ADDENDUM 3

6/4/2025
Capstone at Convington Place
24-064

The Banyan Foundation

1 4TH FLOOR ELECTRICAL PLAN - AREA 1
3/32" = 1'-0"

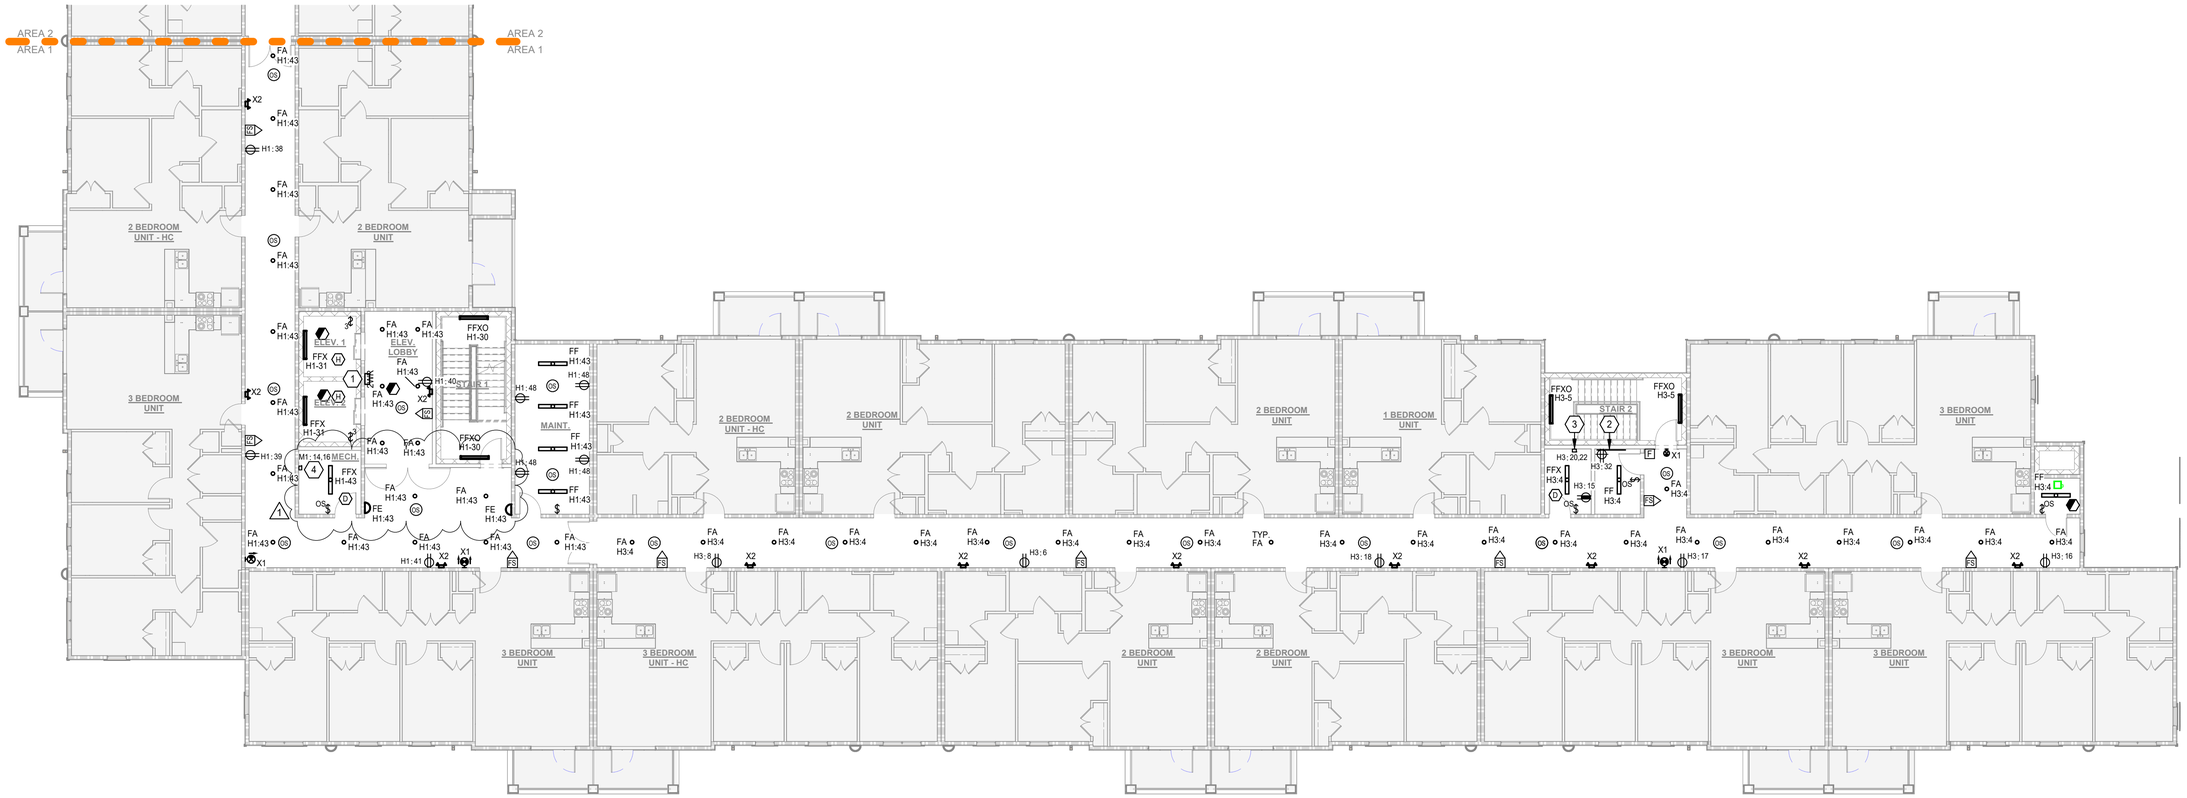
Add 1.82 **E401 – 4th Floor Electrical Plan – Area 1**
- Note changes to 1E401.

1 4TH FLOOR ELECTRICAL PLAN - AREA 2

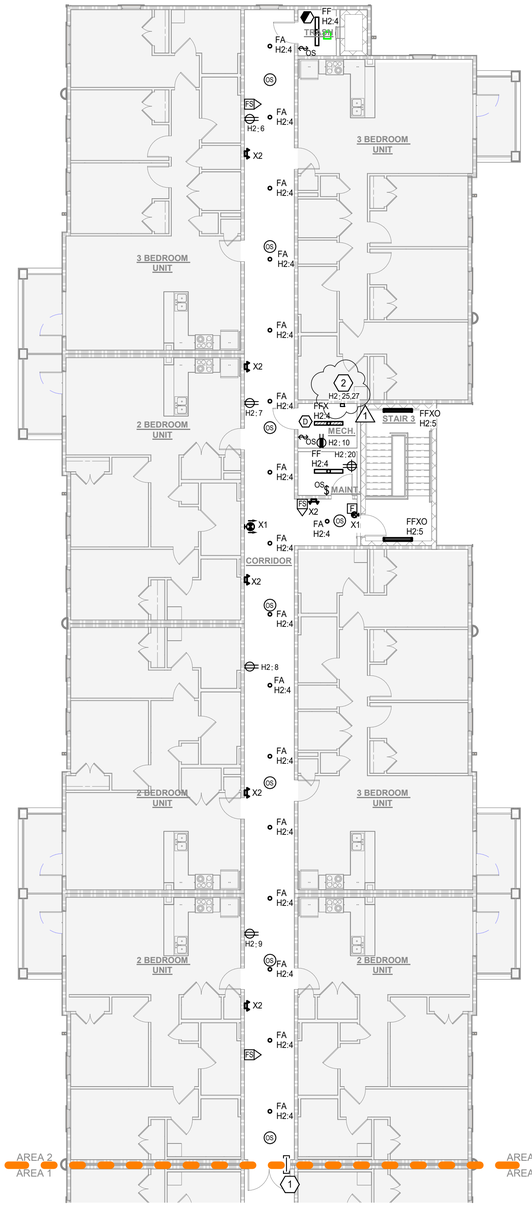
Add 1.83 **E402 –4th Floor Electrical Plan – Area 2**
- Note changes to 1E402.

1 1ST FLOOR COMMUNITY AREA - LIGHTING & FIRE ALARM PLAN
3/16" = 1'-0"

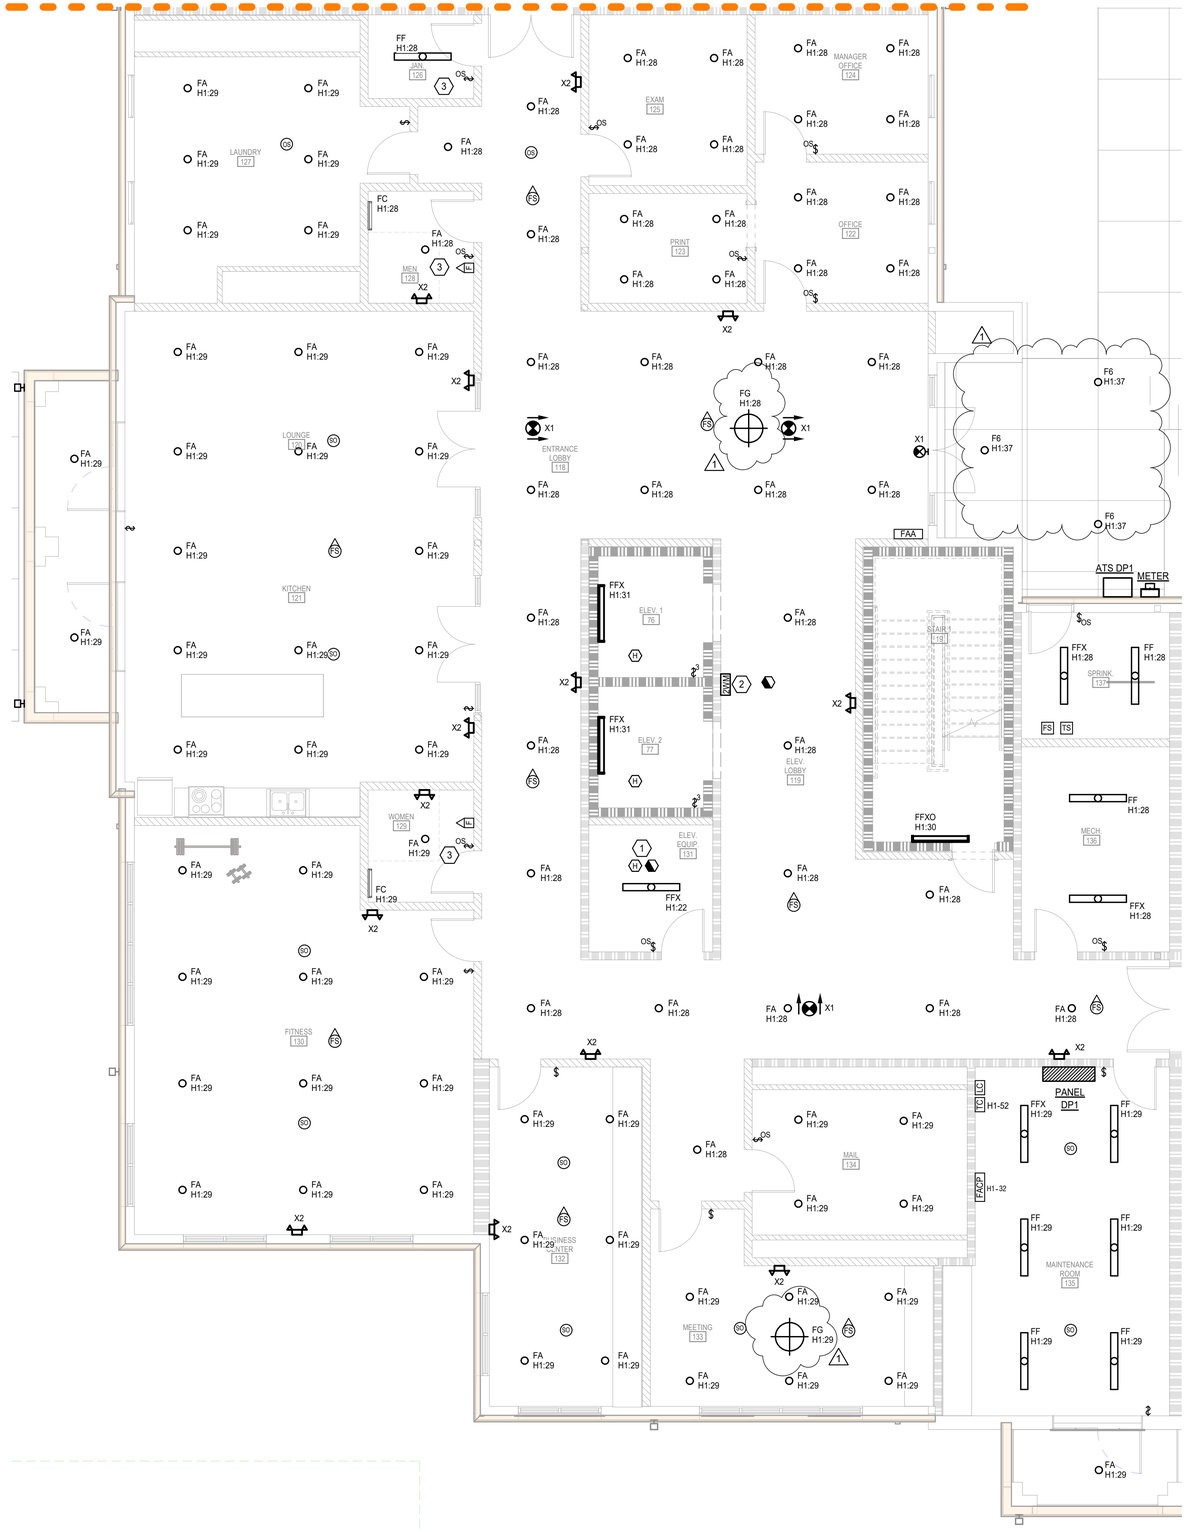
Add 1.85 **E601 – 1st Floor Community Area – Lighting & Fire Alarm**
- Note changes to 1E601.
- Note changes to sheet numbers.

1 POWER RISER DIAGRAM
NO SCALE

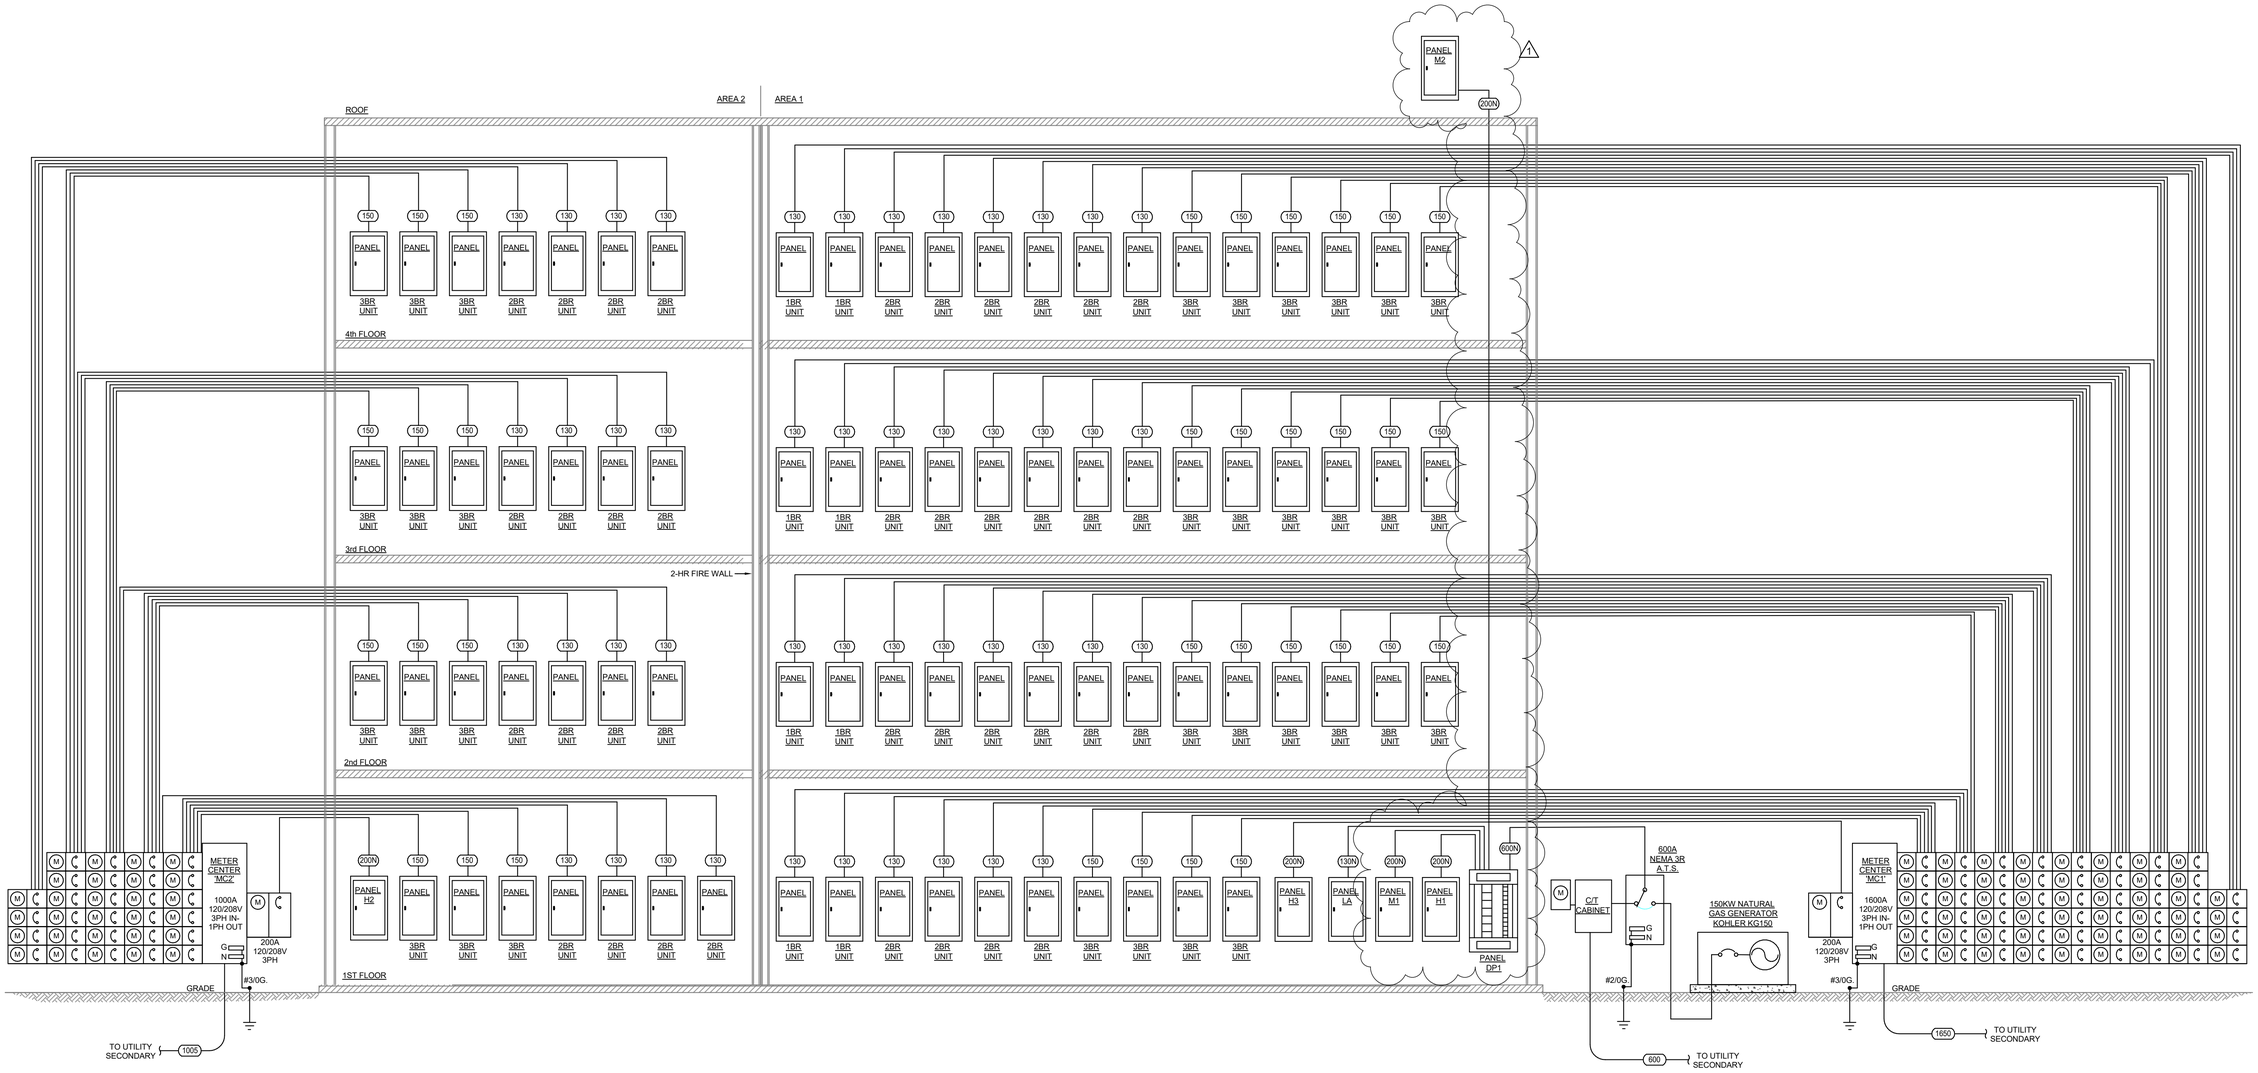
Add 1.91 **E700 – Power Riser Diagram**
- Note changes to 1E700.
- Note changes to 2E700.
- Note changes to sheet numbers.

1 PARTIAL 1ST FLOOR MECHANICAL PLAN - AREA 1
3/32" = 1'-0"

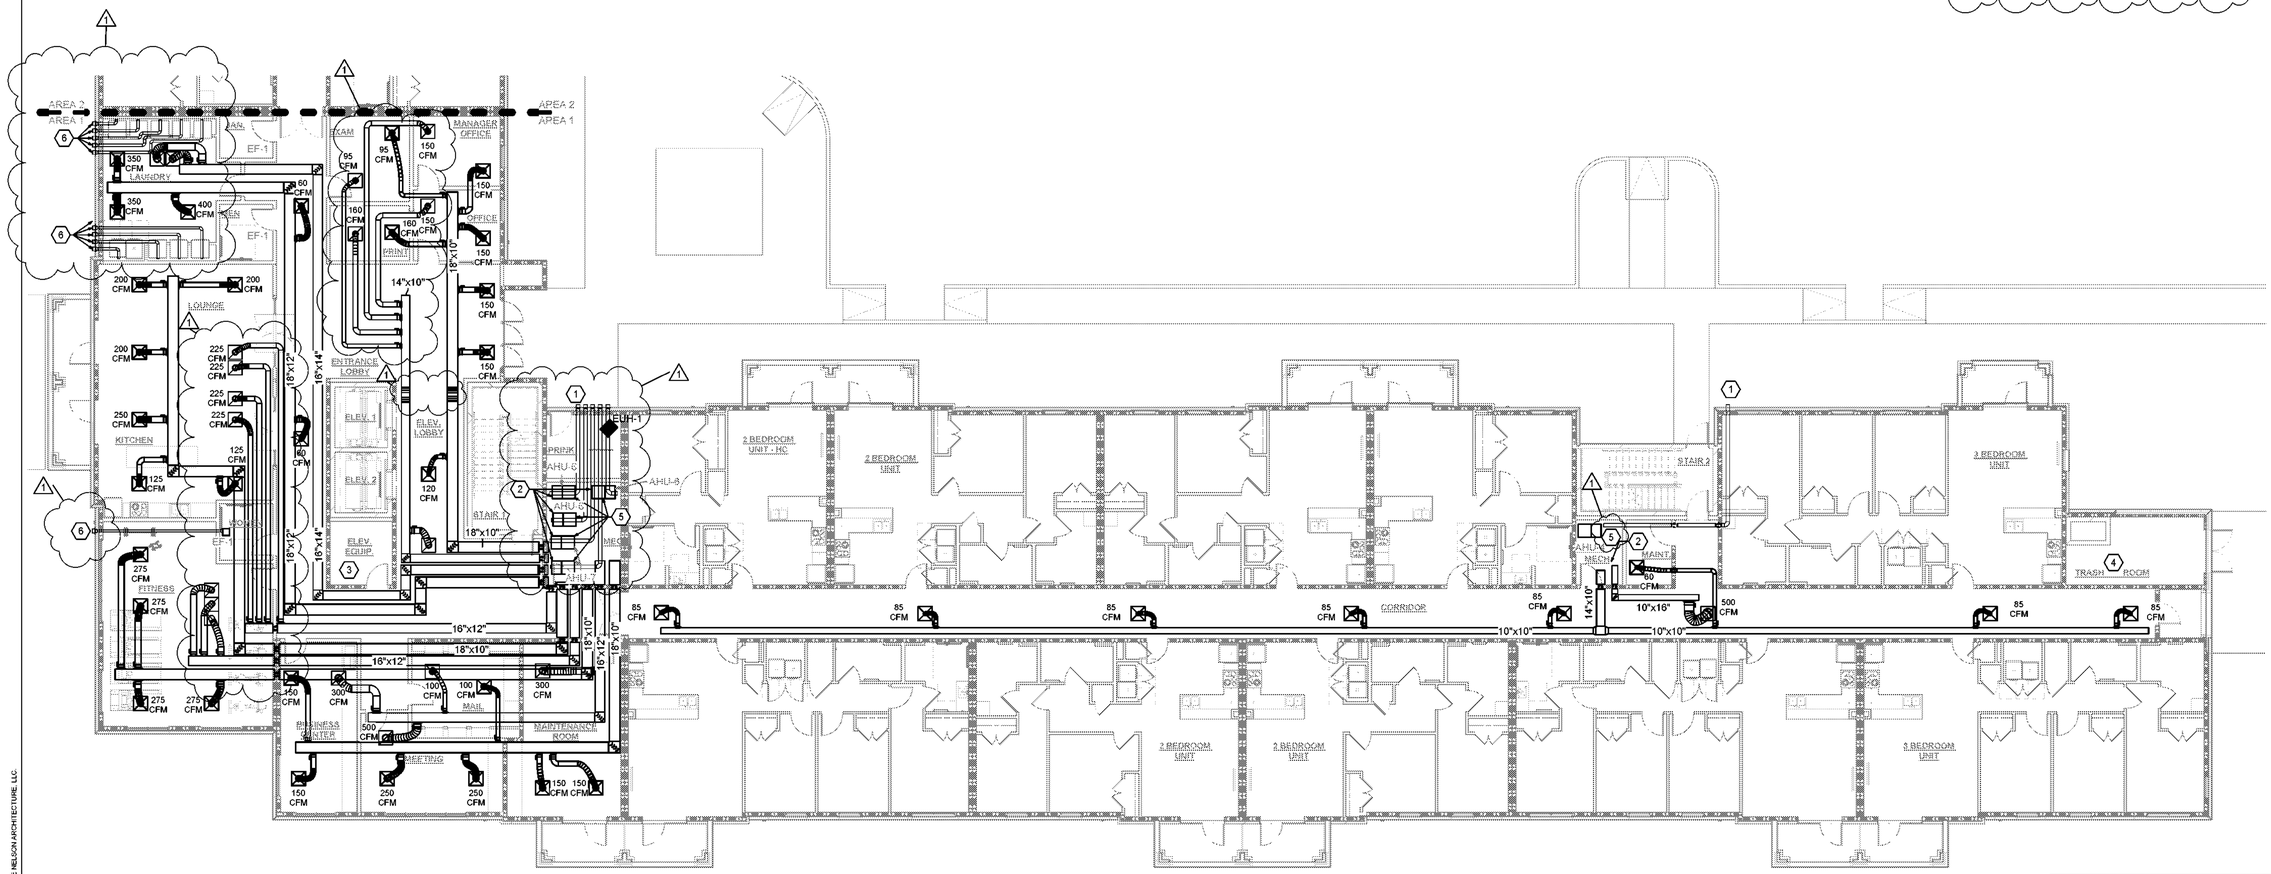
Add 1.54 **M201 – Partial, 1st Floor Mechanical Plan – Area 1**
- Note changes to 1M201.
- Note changes to Specific Notes.

1 PARTIAL 1ST FLOOR MECHANICAL PLAN - AREA 2
3/32" = 1'-0"

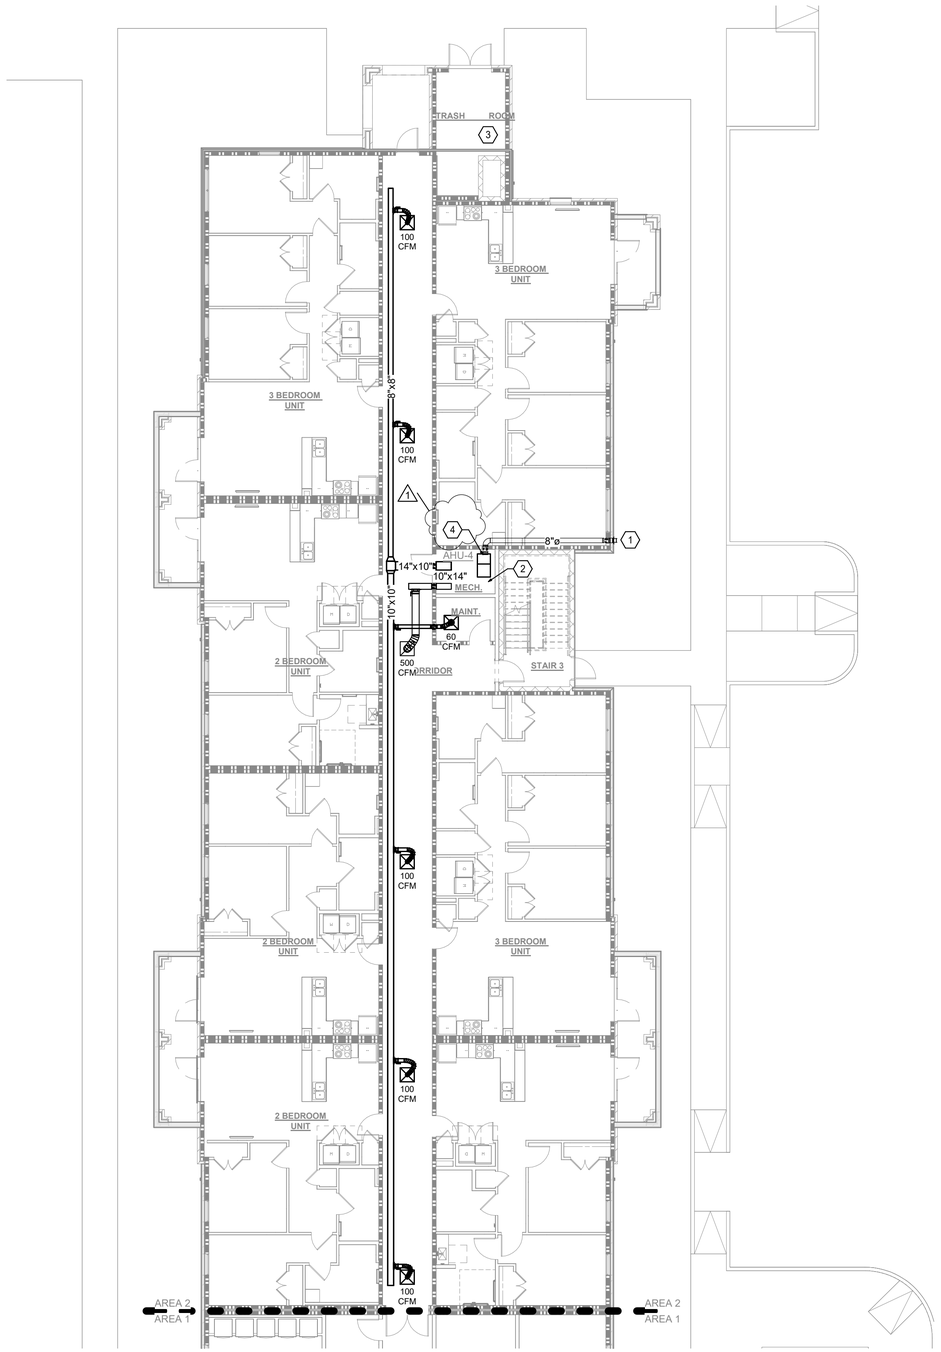
Add 1.55 **M202 – Partial, 1st Floor Mechanical Plan – Area 2**
- Note changes to 1M202.
- Note changes to Specific Notes.
